TITLE: Approval of the City of St. Louis Park Carpenter Park Regional Stormwater Management Plan.

RESOLUTION NUMBER: 17-027

MEETING DATE: March 23, 2016

To: Heidi Quinn, *Permitting Technician*, Minnehaha Creek Watershed District
From: Erik Megow, Wenck Associates, Inc.
Date: March 20, 2017
Subject: Carpenter Park Regional Stormwater Proposal

Figure 1. This figure shows the Carpenter Park BMP, its drainage area, and the pipeshed it shares with the future development (this Figure was developed from a St. Louis Park Stormwater Drainage Map)

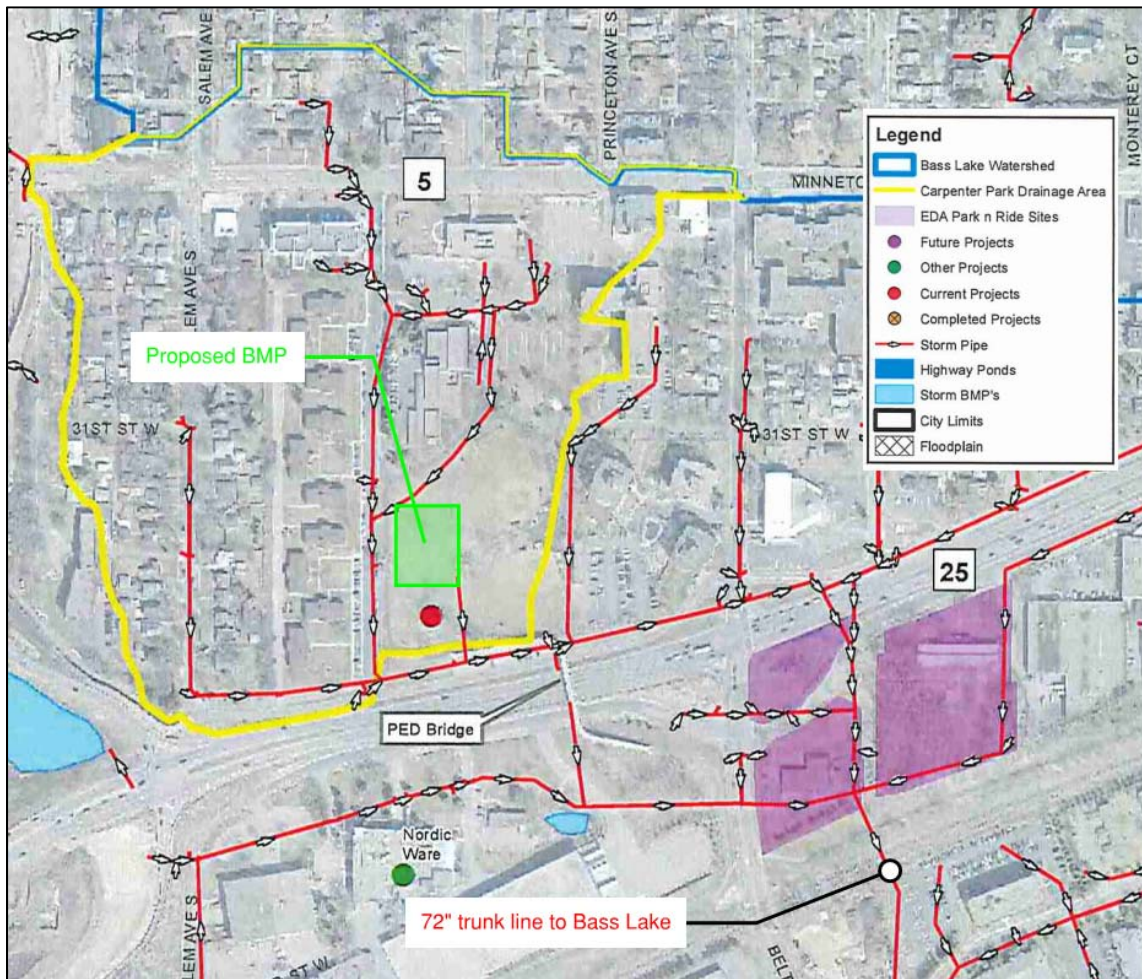
This memo summarizes the proposed stormwater facilities and their performance for the Carpenter Park regional facility. The City of St. Louis Park and WSB & Associates have provided preliminary plans and calculations showing how the proposed facility is designed to off-set redevelopment project downstream of the facility. Runoff from the future re-development and proposed regional facility discharge to the same 72" trunk line (storm sewer) that discharges to Bass Lake. Figure 1 below shows the proposed location of the BMP, the location of the EDA Park & Ride sites to be developed and the 72" trunk line that directs the pipeshed and its runoff to bass lake.

The Carpenter Park regional facility will direct low flow rain events to an underground storage facility to be built beneath the park. The runoff will be directed to the facility with a diversion structure at the intersection of Raleigh Avenue and MN 7 Service Road. This diversion structure will direct low flow events to an underground storage/pond. The pond will be designed to capture at least 37,964 cubic-feet (cf) of runoff below its overflow outlet. The volume below the overflow outlet will be pumped through a primary outlet to the vault containing the filters at a rate of ~0.25 cubic-feet per second (cfs). The 0.25 cfs pumping rate will allow the filtration volume (37,964 cf) to be filtered through the vault in less than 48 hours. A preliminary design form WSB is shown in Figure 2. The BMP as described will provide rate control for the 1, 10, 100-year storm event at 8.5 cfs, 2.2 cfs, and 1.5 cfs, respectively.
